SUBJECT: WEATHERHILL (SUB-13-04)

I am writing on behalf of JT Smith Companies to request that the application for the Subdivision of the Weatherhill Properties (SUB-13-04) be deemed complete upon receipt of this letter. I have prepared this letter, as well as a revised preliminary development plat (dated October 21, 2013) to show that the revised plans satisfactorily address the comments provided by the City in the August 29, 2013 incompleteness notification letter and to show that CDC 85.200(A)(1) and (11) are satisfied. As the applicant has shown below and within the previous submission materials, no feasible alternative exists, therefore a cul-de-sac should be permitted.

SLOPE ANALYSIS PLAN W/SIGNIFICANT TREES
WEATHERHILL
SUBDIVISION
 WEST LINN, OR
 LF 7, LLC
J.T. SMITH
 companies

TENTATIVE SUBDIVISION PLAT
**WEATHERHILL
SUBDIVISION**
WEST LINN, OR
LF 7, LLC

SHEET TITLE
SLOPE ANALYSIS
SHEET NUMBER

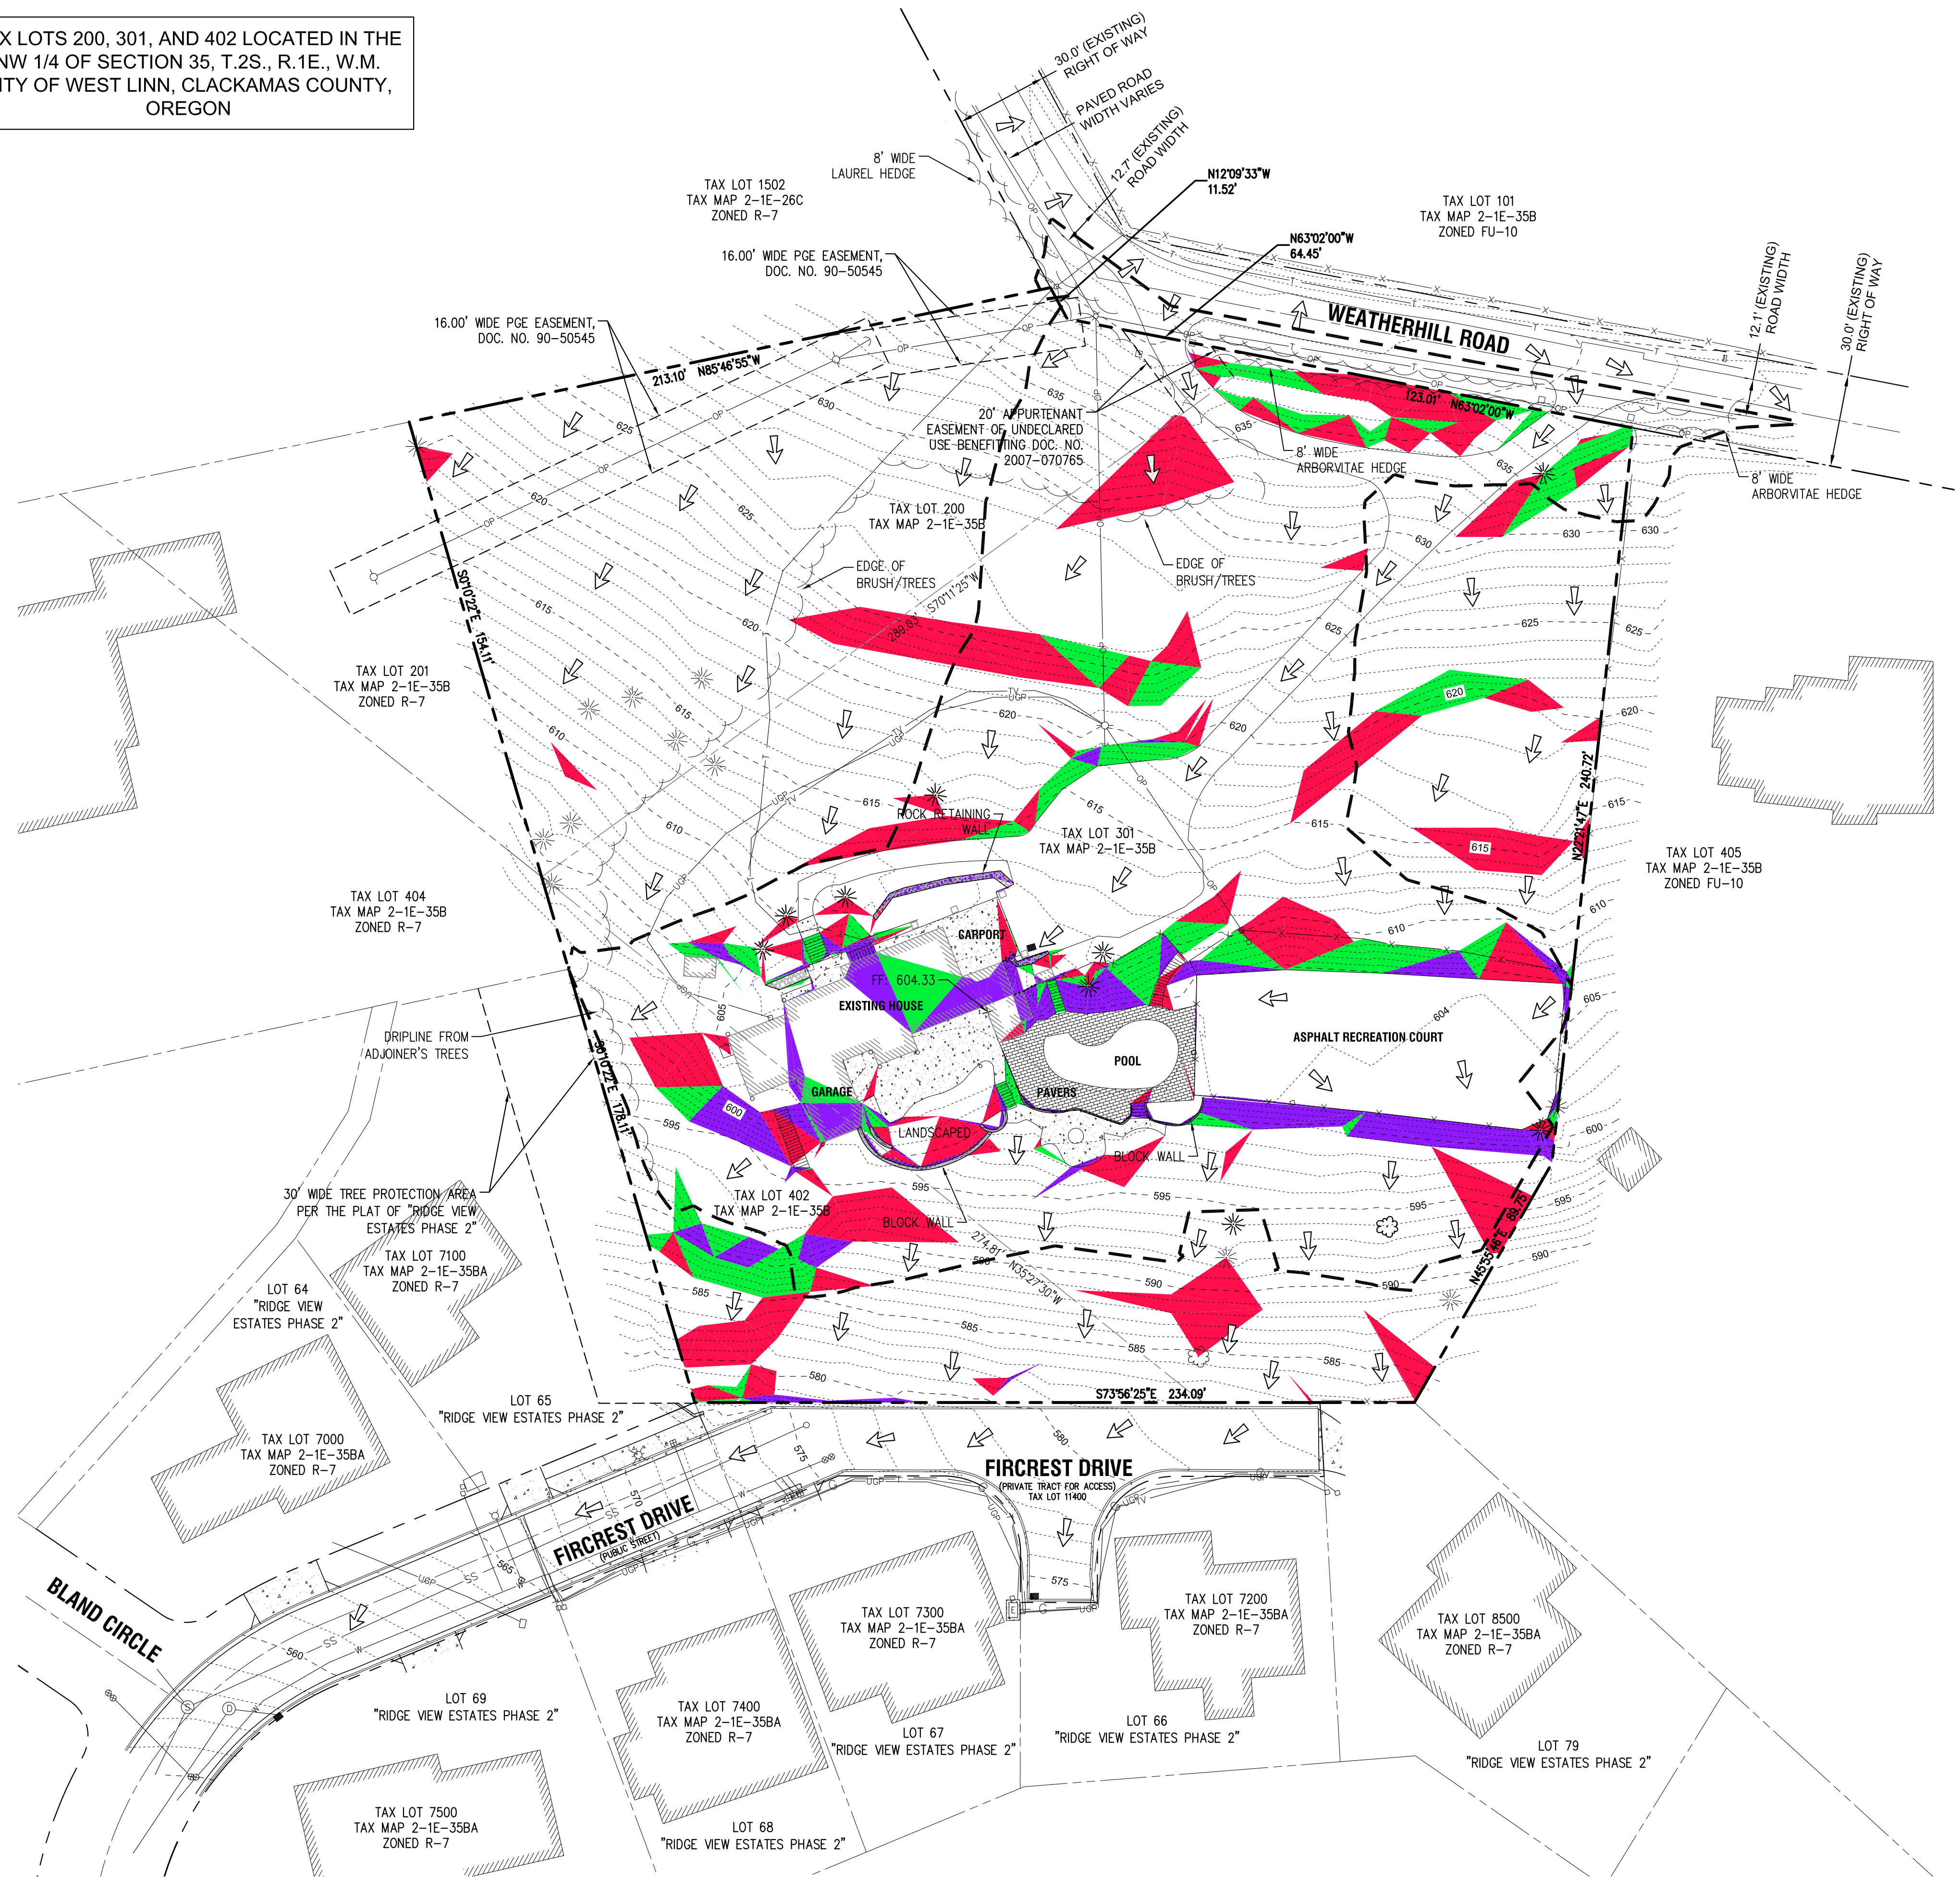
| Section 85.170(J)(9) | Retention of significant trees on type I and II lands | The Applicant has provided a revised slope analysis showing the trees proposed to be retained and removed and the proposed road grading envelopes. All significant trees which are not affected by road grading and therefore exempted through section 55.100(B)(2)(f) will be retained. |

SHEET TITLE
SUBDIVISION PLAT
SHEET NUMBER
C2.0

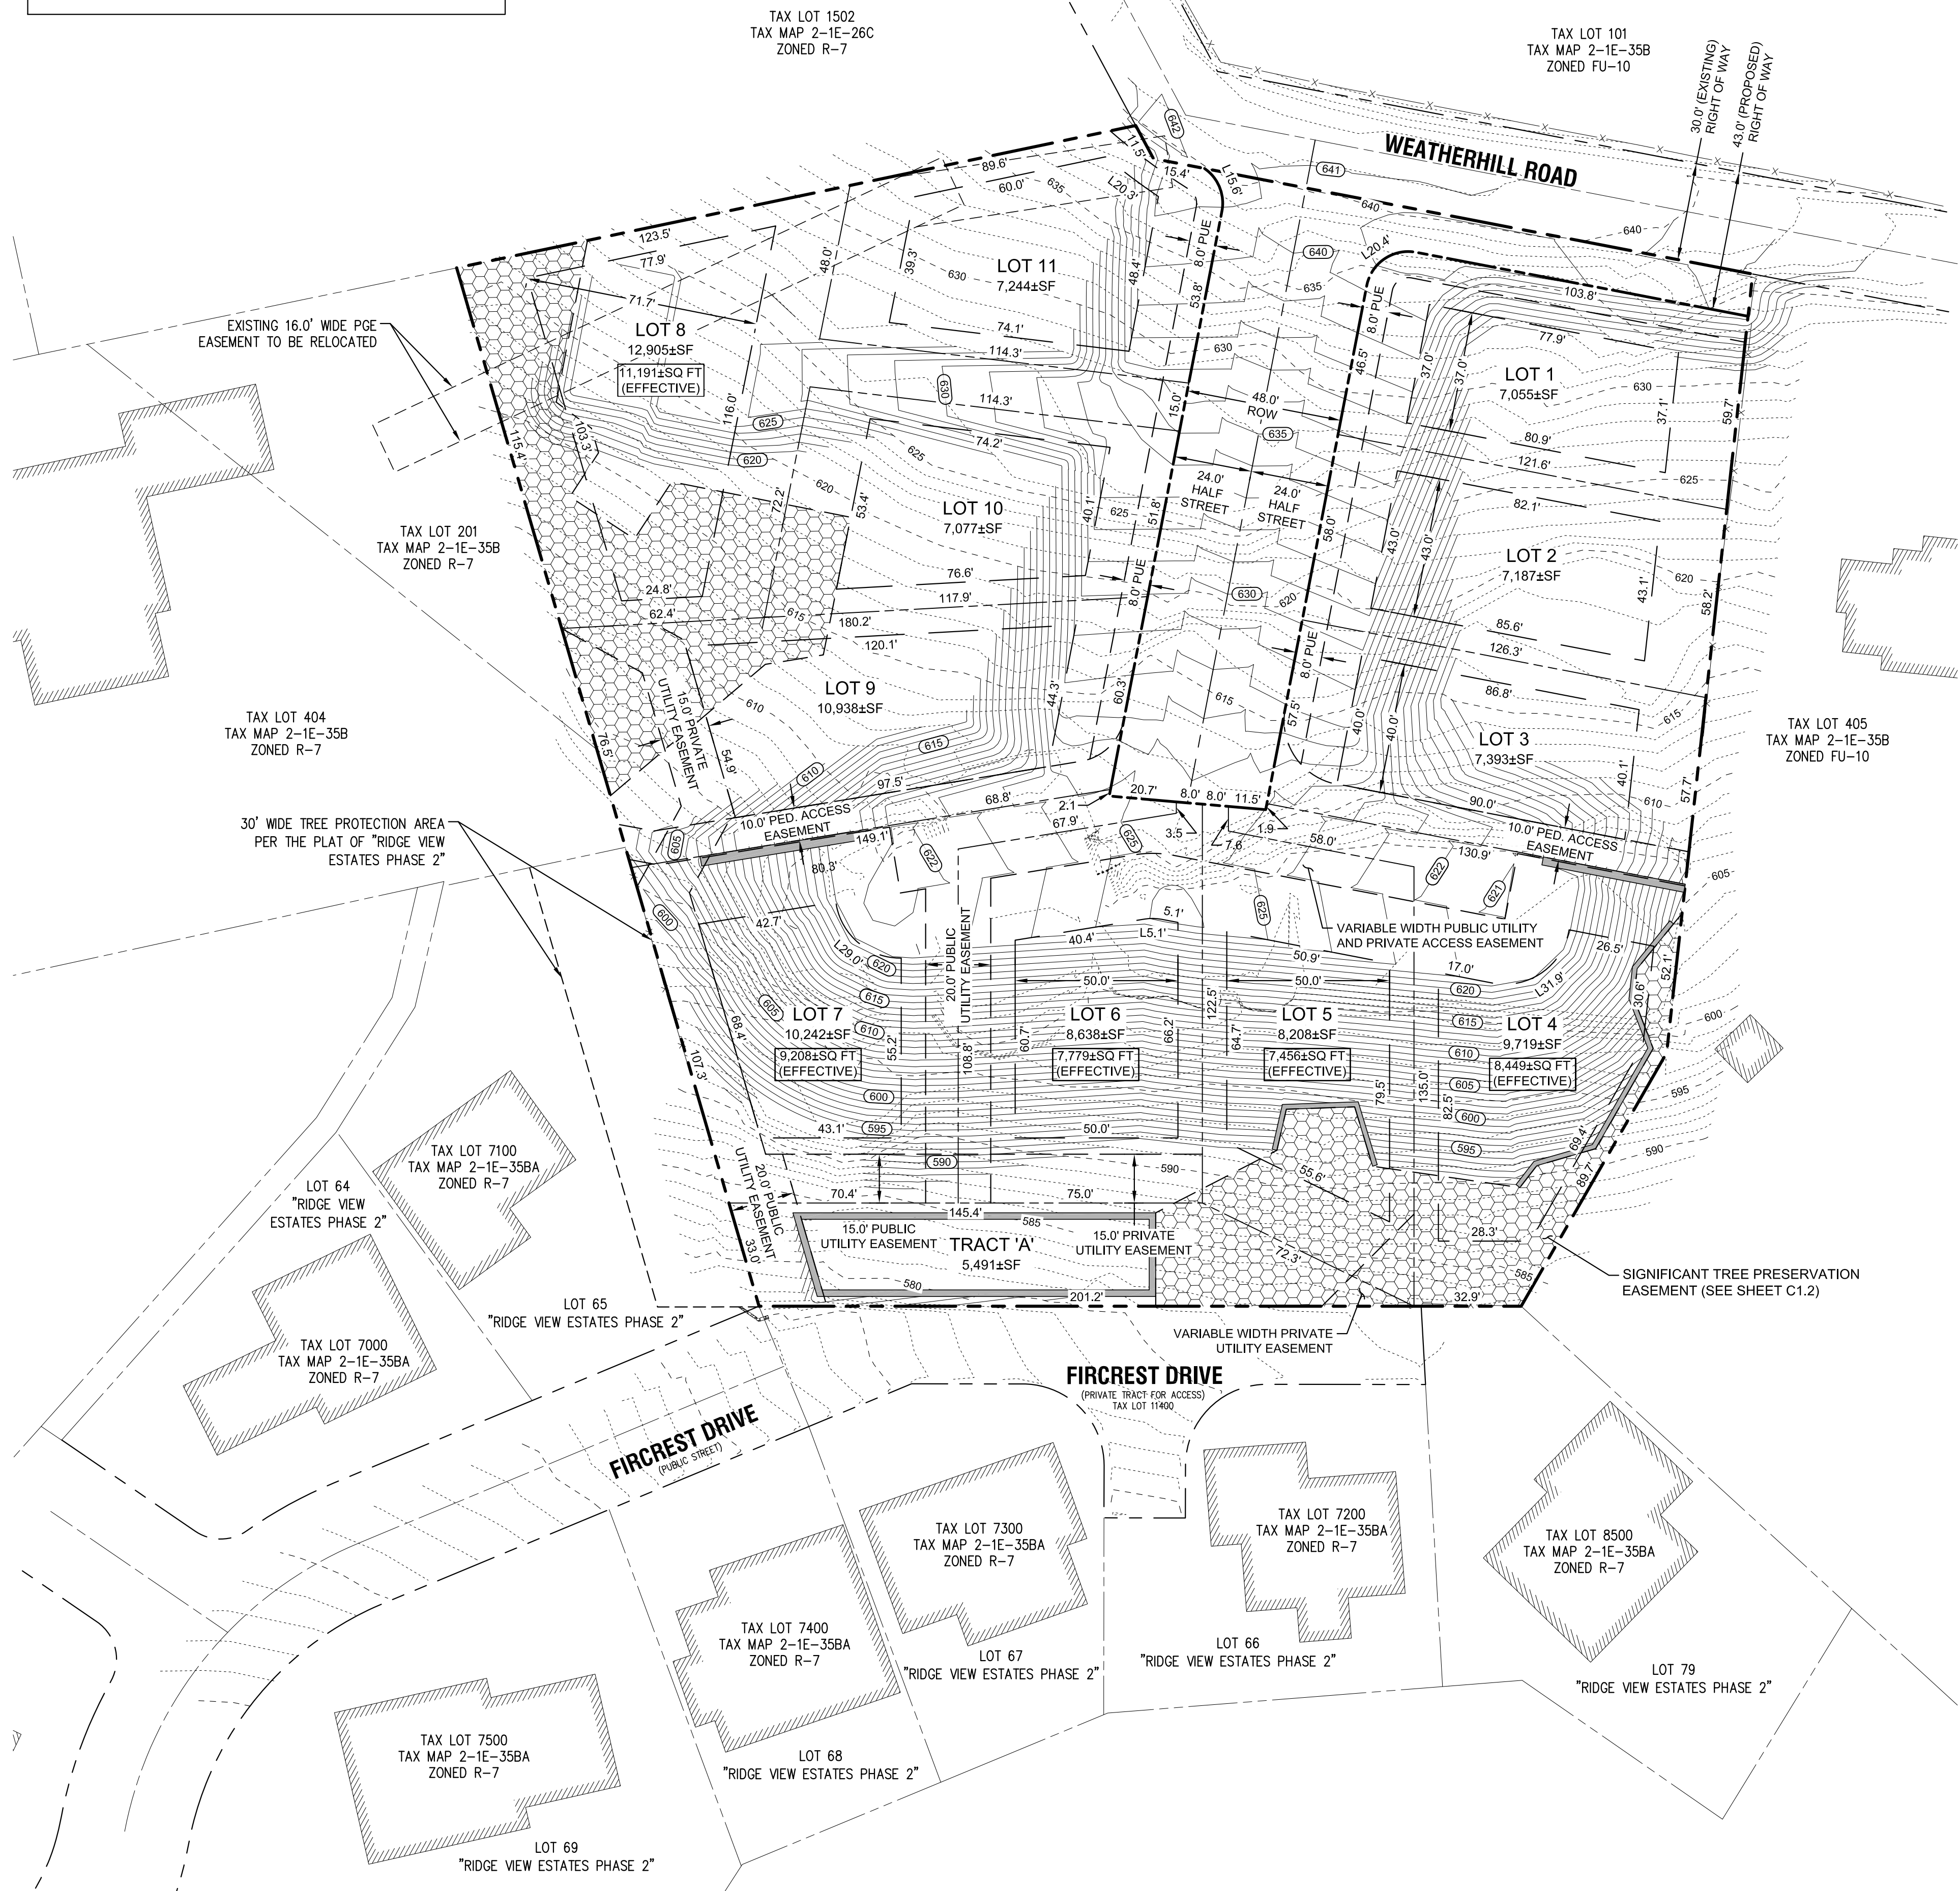
| Planning Comments | | |
|--|---|---|
| Section 85.160(D)(4) and 85.170 (A)(3) | Provide legal description of the tract boundaries. | The Applicant's 8/1 submission contains a legal description on the Existing Conditions Plan and on the Tentative Subdivision Plat. The description reads "Tax Lots 200,301, and 402 located in the NW ¼ of Section 35, T.2S., R.1E., W.M. City of West Linn, Clackamas County, Oregon." |

| 85.200(B)(3) | Lot Size and Shape – Lot 9 does not meet the 2.5 times rule of 12.070(D). | Measuring from the center of lot 9, the ratio of width to depth is 2.47. This meets the requirements of section 12.070(D). |
